ACCESSION NBR: 8610080407 DOC. DATE: 86/09/29 NOTARIZED: NO DOCKET #
 FACIL: 50-400 Shearon Harris Nuclear Power Plant, Unit 1, Carolina 05000400
 AUTH. NAME AUTHOR AFFILIATION
 ZIMMERMAN, S. R. Carolina Power & Light Co.
 RECIP. NAME RECIPIENT AFFILIATION
 DENTON, H. R. Office of Nuclear Reactor Regulation, Director (post 851125)

SUBJECT: Forwards addl comments on Tech Spec Sections 6.4 & 4.6.2.1.b
 re training & surveillance requirements for depressurization
 & cooling sys, respectively & Figure 6-2.1 re corporate
 organization. Final draft Tech Specs encl.

SHEARON HARRIS NUCLEAR POWER PLANT
UNIT NO. 1 - DOCKET NO. 50-400
TECHNICAL SPECIFICATION COMMENTS

Final Draft TS Comments

Figure 6.2-1

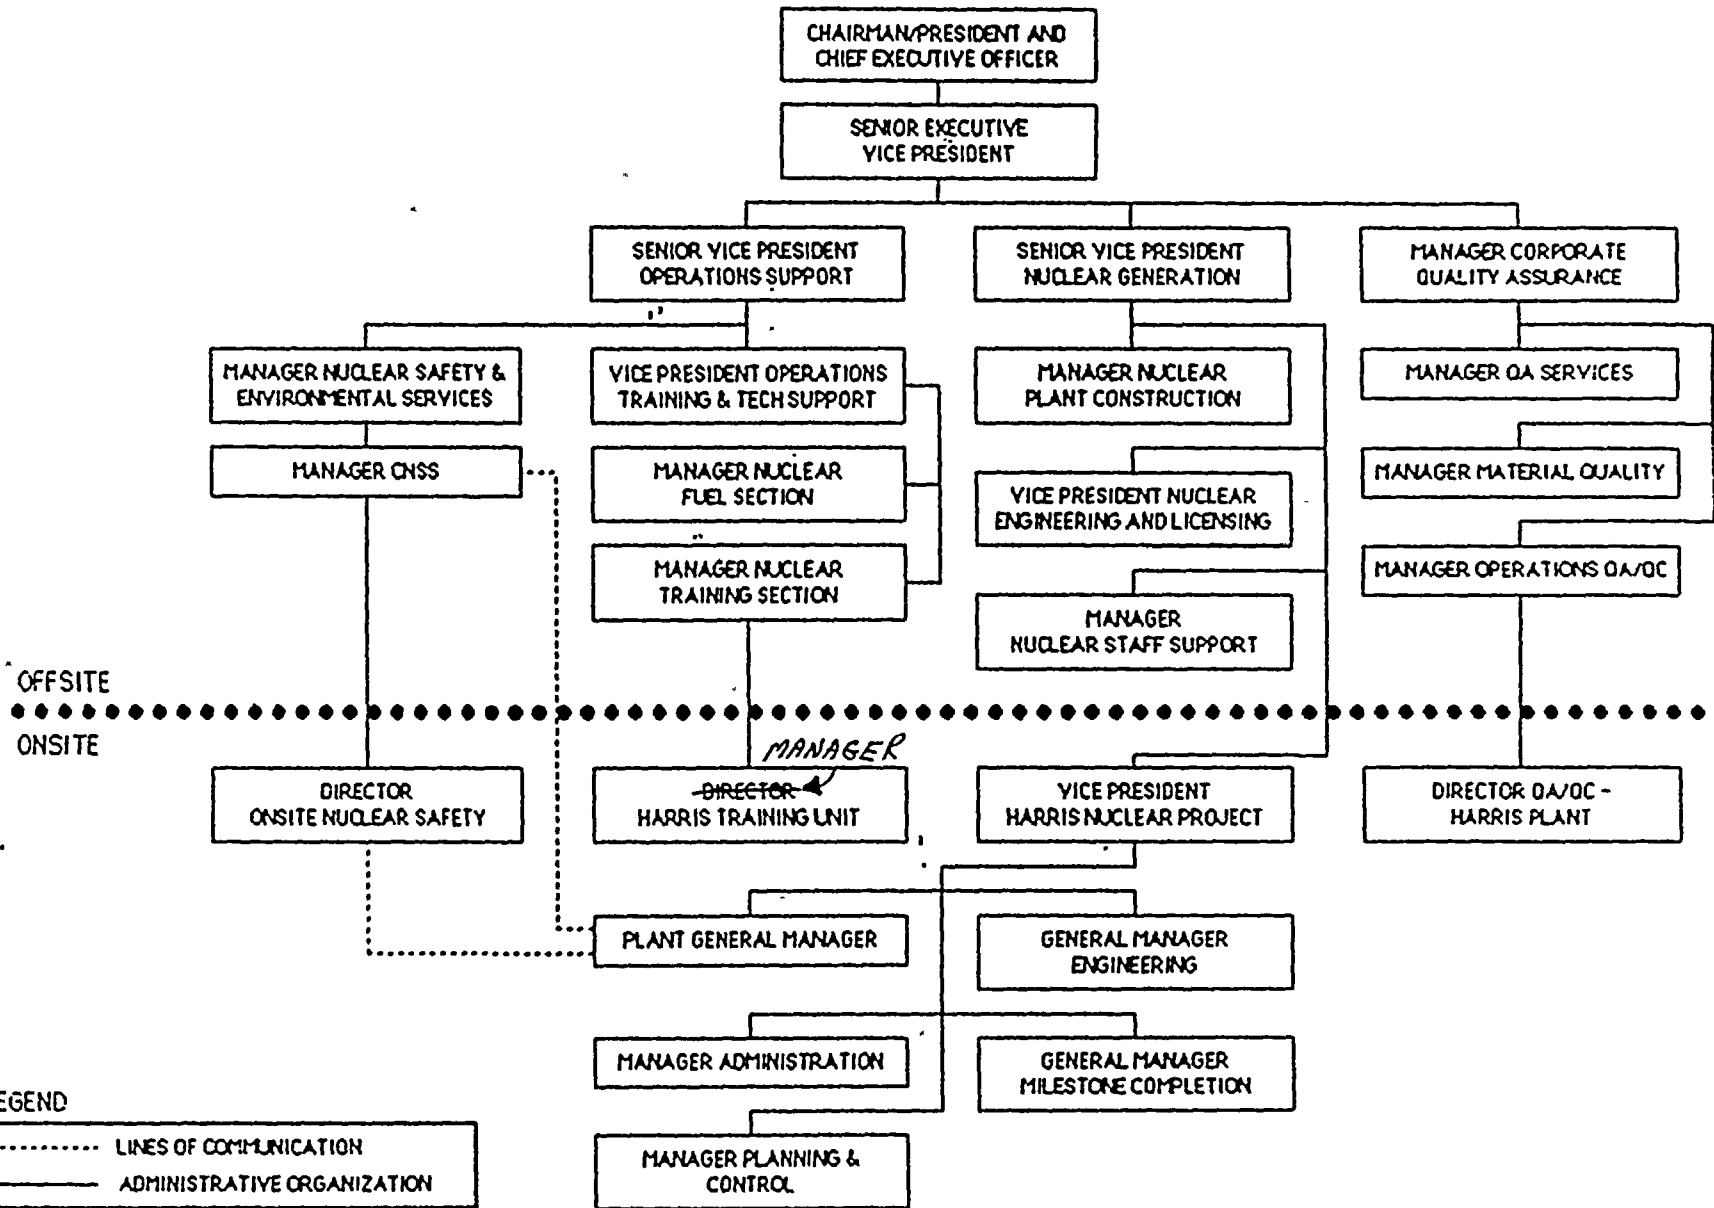
IN BOTH THE FIGURE AND IN SECTION 6.4 CHANGE THE TITLE "DIRECTOR HARRIS TRAINING UNIT" TO "MANAGER HARRIS TRAINING UNIT".

CORPORATE MANAGEMENT HAS CHANGED THE TITLE OF THIS POSITION. NEITHER THE PERSON HOLDING THE POSITION OR THE DUTIES OF THE POSITION HAVE CHANGED. THE CHANGES TO THE FSAR AMENDMENT NUMBERS IS TO MAKE THE TECH SPECS CONSISTENT WITH THE LATEST FSAR CHANGES.
